City of Portland
Bureau of Development Services

Staff Presentation to the **Portland Design Commission**

Design Review Hearing #1
LU 14-230014 DZM AD
Block 136

December 18, 2014

33.266.310.C. Number of Loading Spaces – *STAFF DOES NOT SUPPORT*

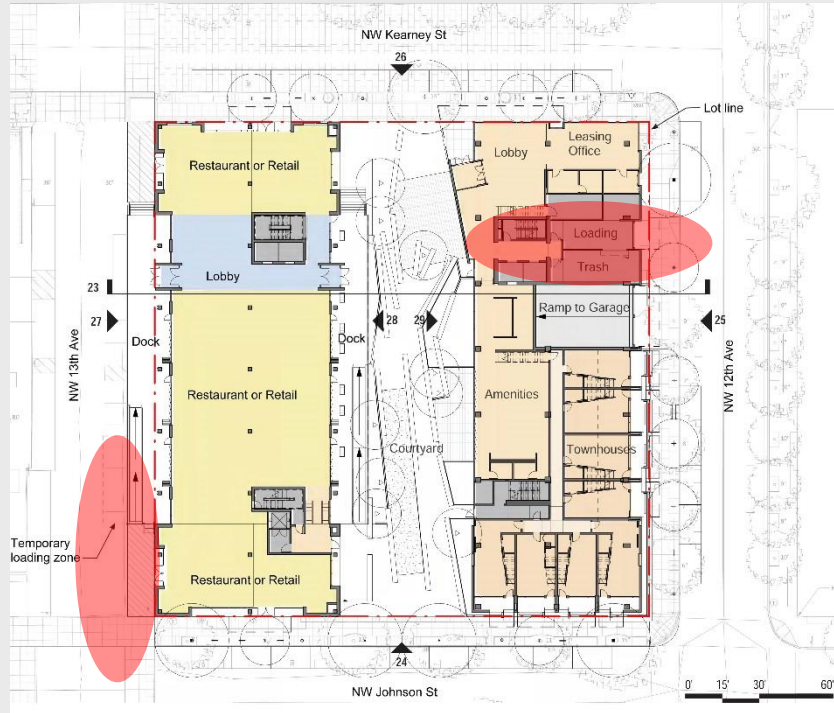
Two (2) loading spaces meeting Standard A are required. Project proposes one (1).

Until the applicant obtains the full approval of PBOT's Parking Control Manager for loading within the NW 13th Ave right-of-way, the approval of an Adjustment to 33.266.310.C. Quantity of Loading Spaces is not warranted.

33.140.210.B.2. Rooftop Access & Mechanical – STAFF SUPPORTS

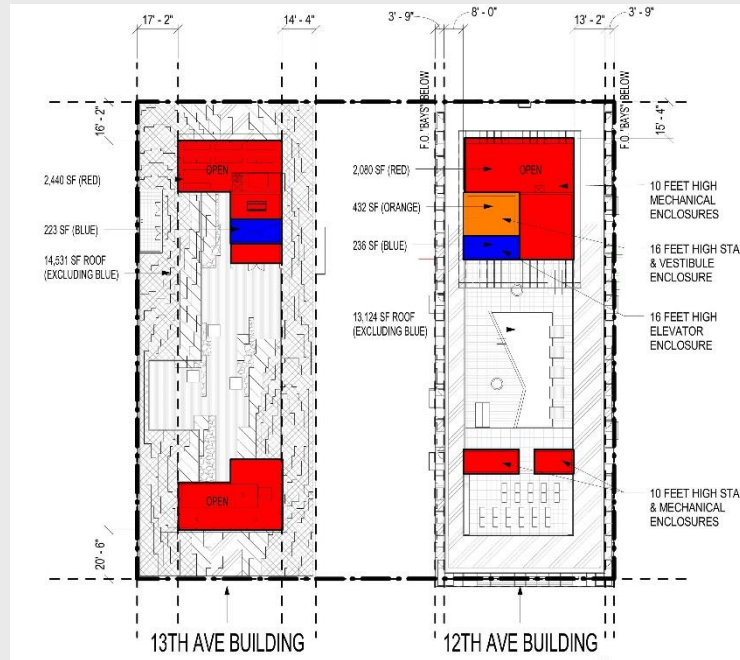
Set back – 15' from roof edges | 12th Ave Bld – 13' from 12th Ave, 8' from Courtyard.

Projection Height – 10' max | 12th Ave Bld – one 13' projection (air unit).

Rooftop Coverage – 10% max | 12th Ave Bld – 18.8%, 13th Ave Bld – 16.5%.

33.266.310.D.a. Size of Loading Spaces – *STAFF SUPPORTS*

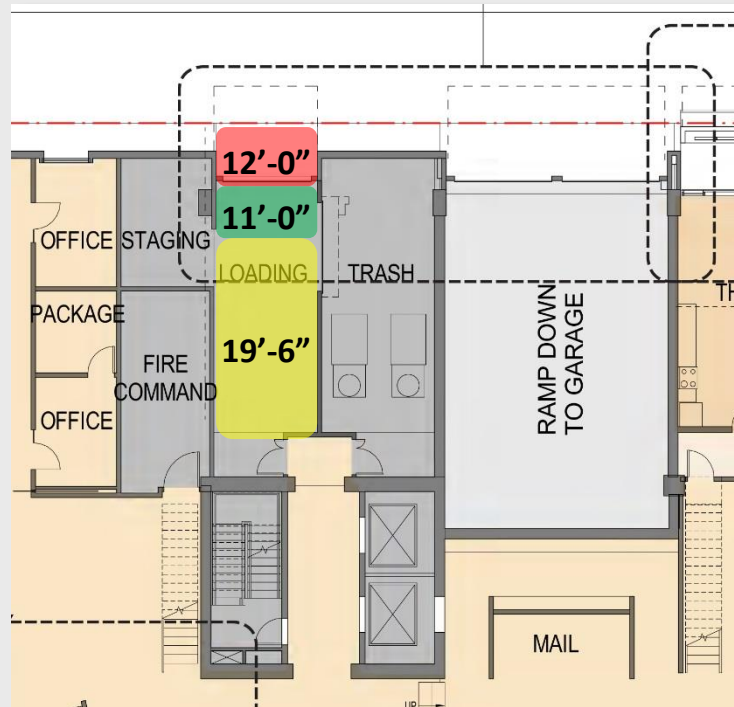
Standard A Loading Dimension – length 35', width 10', clear 13'.

12th Ave Build – length 35' x width 10'-11'-5" x 11'-19'6".

STAFF SUPPORTS

33.266.220.C.3.b. Bike Parking Space Dimension – *STAFF SUPPORTS*

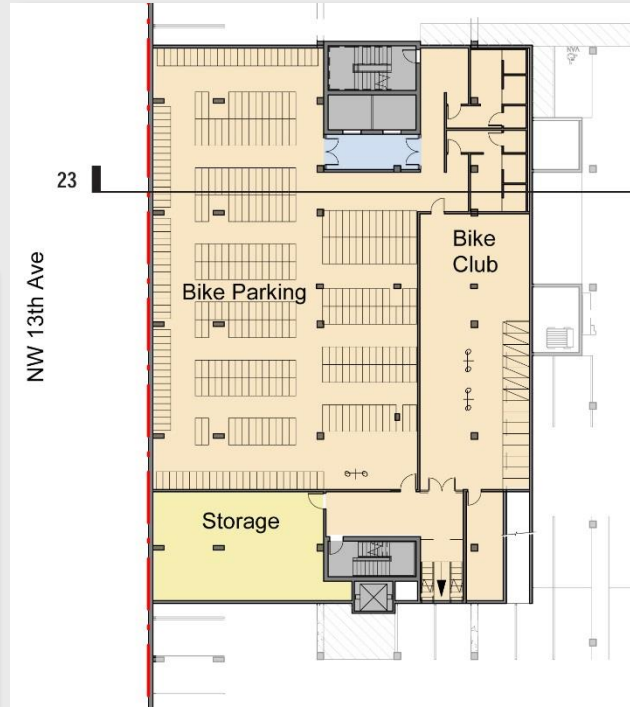
Long-term Bike Parking Space – 24" x 6' with 5' walk aisle.

Level P1 Long-term Sparking Space – staggered vertical 18" x 6' with a 5' walk aisle.

STAFF SUPPORTS
